Will the repair of the Cairngorm Funicular Railway work (2)?

January 5, 2021

Figure 2-10 Loosened rock bolt in anchor block (refer defect 7)

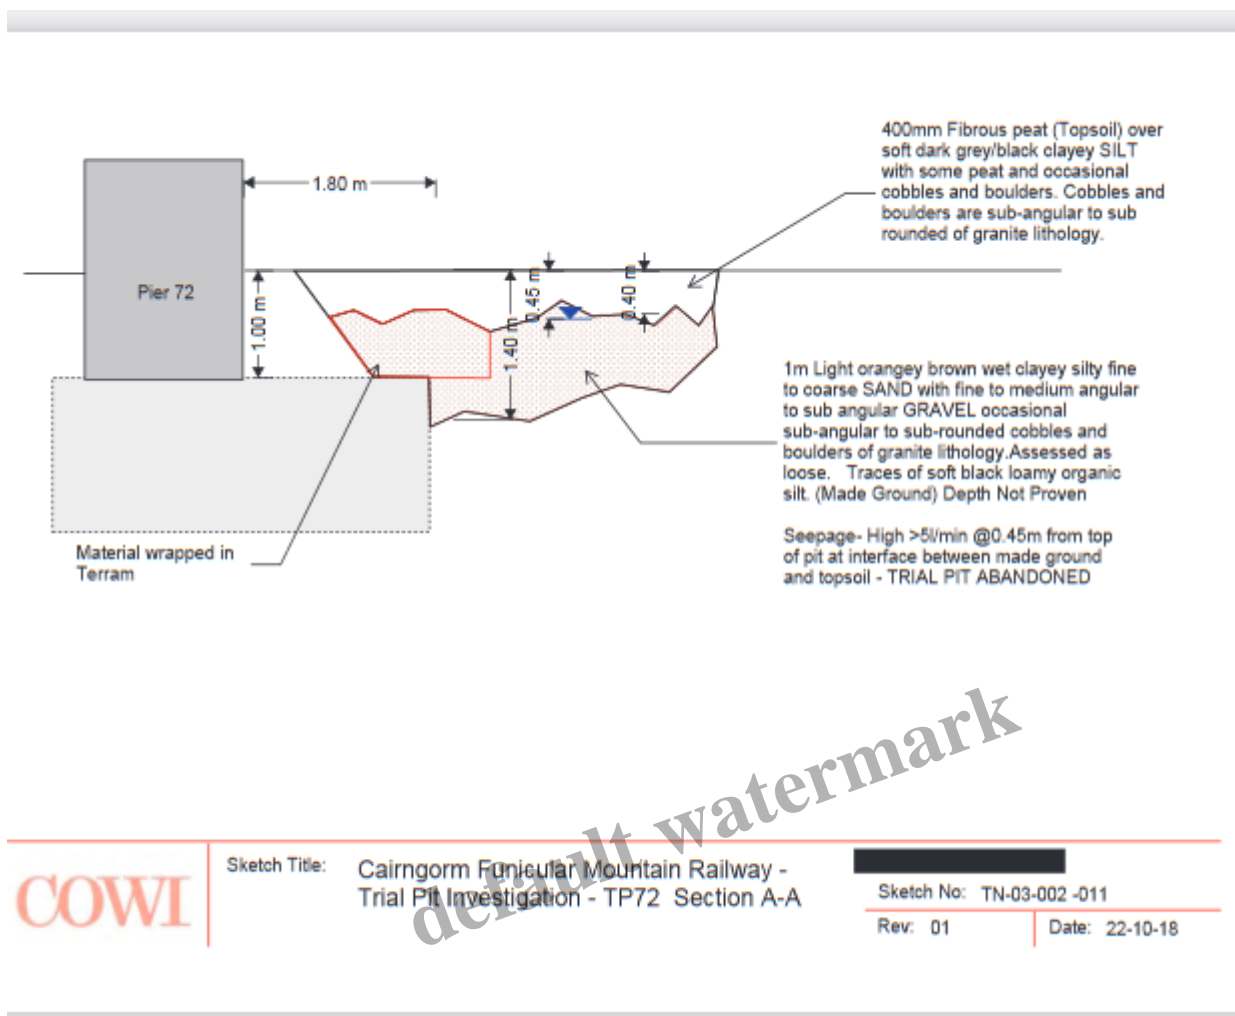
"Some rock bolts at anchor blocks can be loosened by hand. [New observation by COWI/ADAC, Aug 2018] (Page 11, para 2.2.7). The next picture, courtesy of the COWI report (page 13) is of one of those anchor bolts.

Question (1) Where was the routine maintenance schedule that should have been carried out by maintenance staff that allowed this to happen?

Question (2) Is it possible to tighten this bolt taking into account the corrosion on the threads?

It is not known which of the Anchor Blocks this is, or how many of its securing bolts were loose, but these bolts are there for a reason. These Anchor Blocks take the weight/ strain of the approx. 2 x 300m of uphill concrete beams, which are continually trying to slide downhill under the force of gravity. They should be checked on a regular basis and the nuts torqued to a specific setting. Depending on how many of the bolts on any one Anchor Block were loose, the one below it could have been carrying the full weight of 600m of track! You can see from the corrosion on the rock bolt that the nut has been loose for some time.

Question (3) Why was this not noticed at previous inspections?
